# Access Compliance Report

## Public Rights-of-Way

### (Pedestrian Signals)

| ADA ID: C3F196D1F45B                    | Signal Type: Two Push Buttons-Non APS | Overall Compliance: No                  | Severity Score: BTN 1:N/A BTN 2: N/A No BTN: N/A |

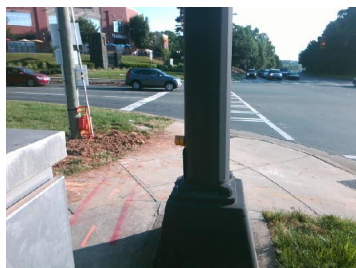
Surveyor Notes: TEXT HT 1/2

PROW/ADA: R410.6, TMUTCD 4e.08, R406.2, R404.2

| Compliance | Description                             | Data    | Compliance | Description                            | Data |
|------------|-----------------------------------------|---------|------------|----------------------------------------|------|
| No         | B 1 Sign Lettering & Contrast?          | No      | No         | B 2 Sign Lettering & Contrast?         | No   |
| Yes        | B 1 Clear Floor Space XSlope (%)        | 1.3     | No         | B 2 Clear Floor Space XSlope (%)       | 10.7 |

| No  | B 1 DistanceTo Curb (in)  | 153.0         | No  | B 2 DistanceTo Curb (in)  | 164.0         |

Possible Solutions: Replace Signal Push Button With APS Button on New Post. Remove & Replace Sign.
